RE: Agreement No. 1774
Project Number T201769002
Traffic Impact Study Services
Task 9A-Dutch Inn – 111 S. DuPont Highway

Johnson, Mirmiran and Thompson (JMT) has completed the review of the Traffic Impact Study (TIS) for the 111 S. DuPont Highway restaurant and retail development, prepared by Duffield Associates, Inc. This task was assigned Task Number 9A. Duffield Associates, Inc. prepared the report in a manner generally consistent with DelDOT's *Development Coordination Manual*.

Table 2
Peak Hour Levels Of Service (LOS)
Based on Traffic Impact Study for Dutch Inn, LLC
Report Dated: July 2017
Prepared by Duffield Associates, Inc.

Site Map

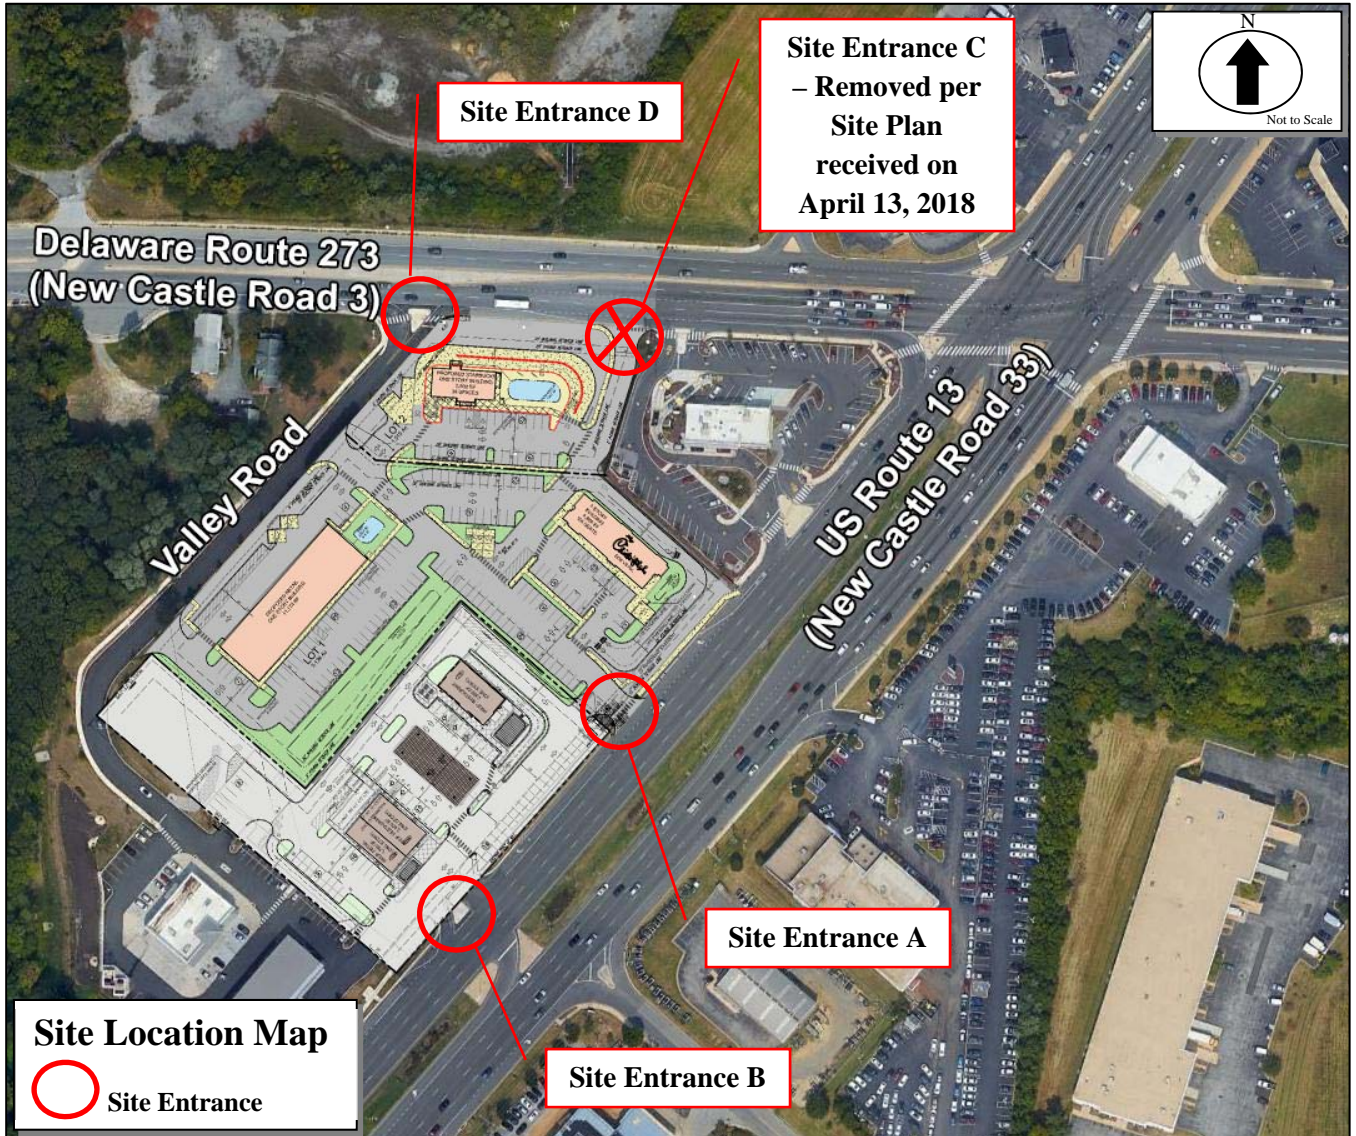
However, in a Site Plan received on April 13, 2018, the proposed right-in/right-out access along Delaware Route 273 (Site Entrance C) has been removed and therefore any recommendations regarding this entrance as a result of the TIS analysis has been omitted from this letter. Construction of the site is expected to be completed in 2019.

In addition, to help improve interconnectivity as well as operations at the site and minimize conflict points along Delaware Route 273, Site Entrance C/Delaware Route 273 intersection should be eliminated. The Site Plan received from Duffield Associates on April 13, 2018, depicts that Site Entrance C has been removed. With the traffic redirected from Site Entrance C, the Site Entrance

Note, a Site Plan received on April 13, 2018 depicts that the proposed right-in/right-out access along Delaware Route 273 (Site Entrance C) has been removed. However, to maintain consistency with the TIS report, the analysis results from Site Entrance C is depicted in this letter.

Should New Castle County approve the proposed development, the following items should be incorporated into the site design and reflected on the record plan. The recommendations below incorporate the removal of Site Entrance C which has been reflected in the Site Plan received on April 13, 2018. All applicable agreements (i.e. letter agreements for off-site improvements and traffic signal agreements) should be executed prior to entrance plan approval for the proposed development.
